**ADDENDUM NO (1) ONE
IFB 17-PW-001
SARA ROAD REHABILITATION PROJECT**

August 11, 2016

Addendum Number (1) One forms part of the contract documents and modifies them in the manner set forth below.

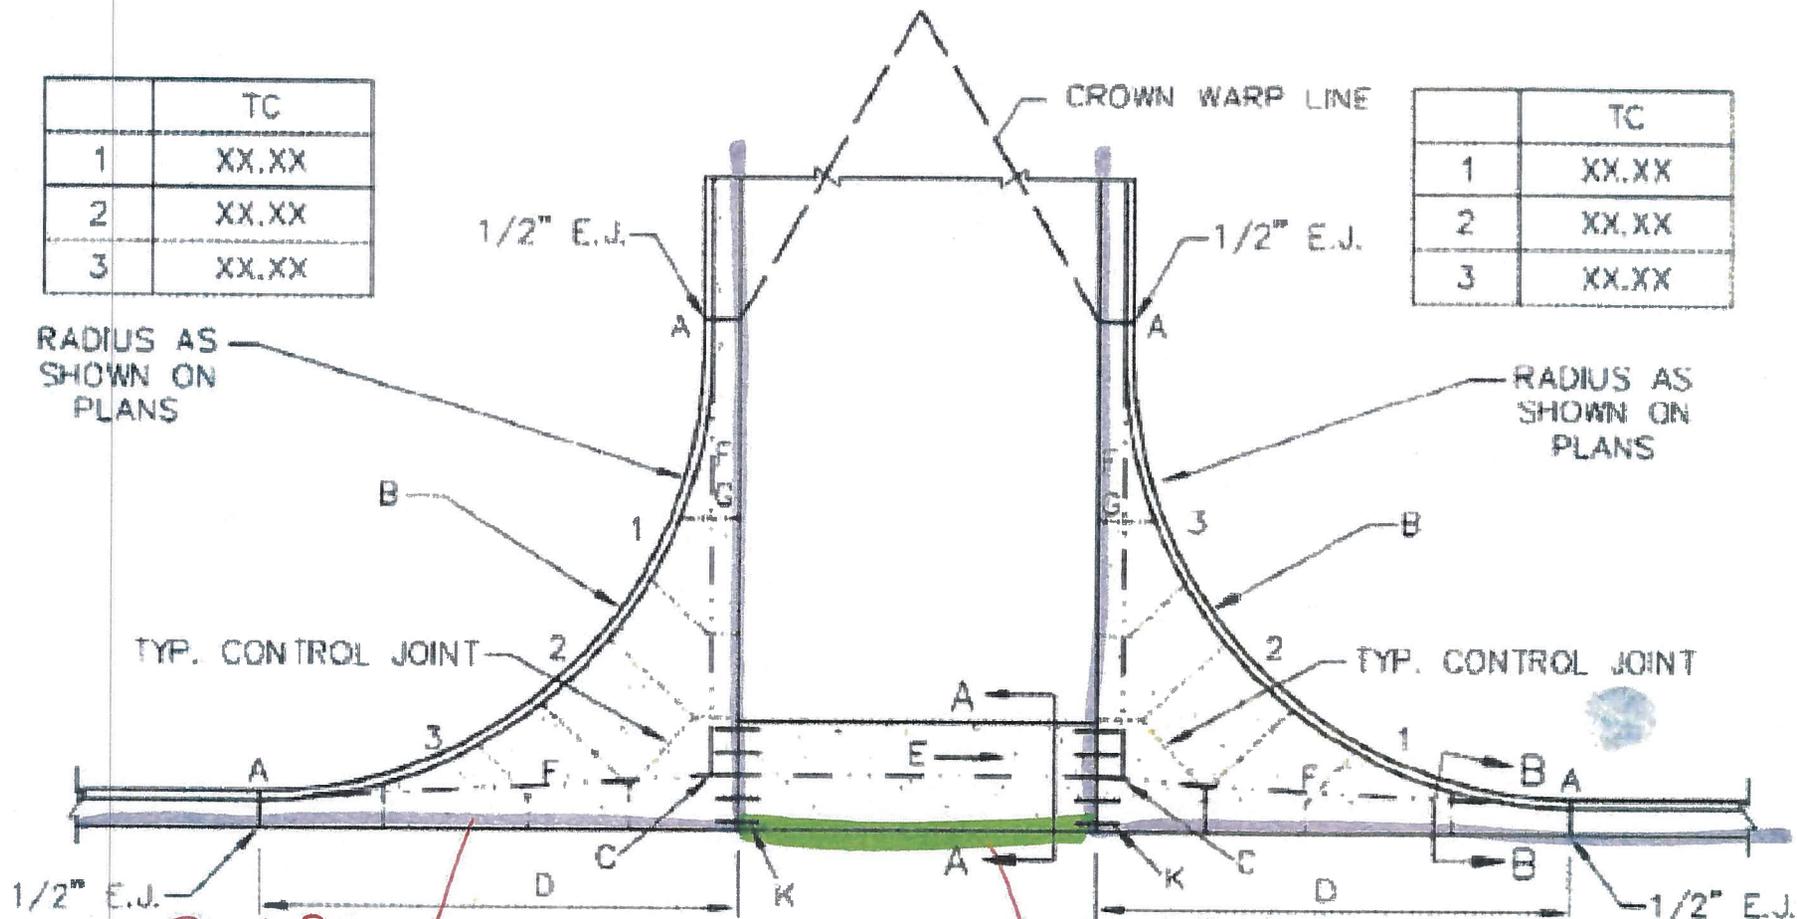
Question: Note #9 found on sheets 2-8 to 2-19 call out to remove and replace concrete fillets. The detail on Sheet 2-5 Section B-B is for an 8" thick concrete reinforced section for the fillets. Since this concrete cannot be measured by lineal foot (bid item 18 above), and the City of Rio Rancho pays this item by square yard, can we have a bid item for 8" thick reinforced concrete for fillets?

Answer: The fillet quantity, welded wire fabric and no. 4 dowel bars shall be considered incidental to bid item 609444 – CONCRETE VERTICAL CURB AND GUTTER 8” X 24”. See attached detail for reference.
